# Access Compliance Report

## Public Rights-of-Way

Intersection ID: 10022822	Main Street: CASTLE_WATCH_AV	Cross Street: N/A	Location: SE
ADA ID: 799F6307E1E3	Ramp Type: PerpDiag	Initial Pass/Fail: Fail	Overall Compliance: No
Severity Score: 48.75			
Codes/Mitigation Info/Possible Solution		Field Measurements/Component Compliance

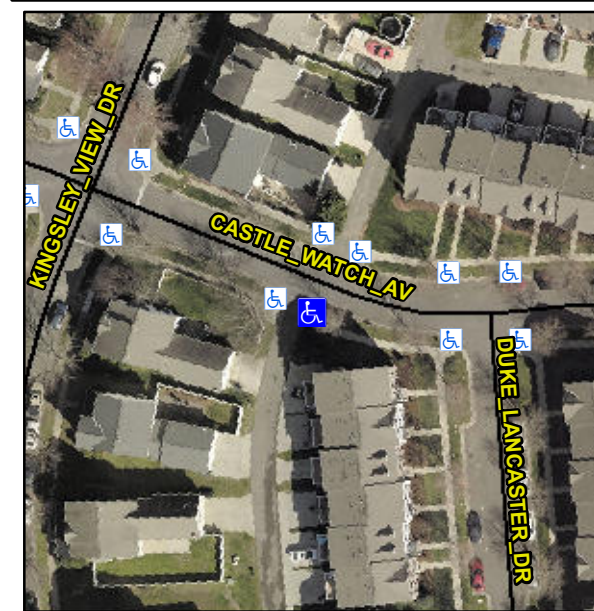
**Not Found, R304.5.1**

Compliance	Description	Data	Compliance	Description	Data
N/A	Ramp Length (in)	226.0	Yes	Ramp Slope (%)	9.3
No	Ramp Width (in)	25.5	Yes	Ramp XSlope (%)	2.7
N/A	Flare Type LT	N/A	N/A	Flare Type RT	N/A
N/A	Flare Slope LT (%)	N/A	N/A	Flare Slope RT (%)	N/A
N/A	Flare Traversable LT?	N/A	N/A	Flare Traversable RT?	N/A
N/A	Landing Length (in)	N/A	N/A	DWS Provided?	N/A
N/A	Landing Width (in)	N/A	N/A	DWS Contrast?	N/A
N/A	Landing Slope (%)	N/A	N/A	DWS Length (in)	N/A
N/A	Landing X Slope (%)	N/A	N/A	DWS Full Width?	N/A
N/A	Landing Curb? (Y/N)	N/A	N/A	DWS Offset (in)	N/A
N/A	Shared Landing?	N/A			
N/A	Gutter Ponding?	N/A	N/A	Gutter Slope (%)	N/A
N/A	Gutter Lip Ht (in)	N/A	N/A	Gutter X Slope (%)	N/A
N/A	Painted X Walk1?	No	N/A	Painted X Walk2?	No
	X Walk 1 Direction	To NE		X Walk 2 Direction	To NW
N/A	X Walk 1 Width (in)	N/A	N/A	X Walk 2 Width (in)	N/A
	X Walk 1 Slope (%)	2.0		X Walk 2 Slope (%)	3.7
	X Walk 1 X Slope (%)	2.0		X Walk 2 X Slope (%)	3.8

**Remove & Replace Curb Ramp With Two New Directional Ramps or Equivalent.**
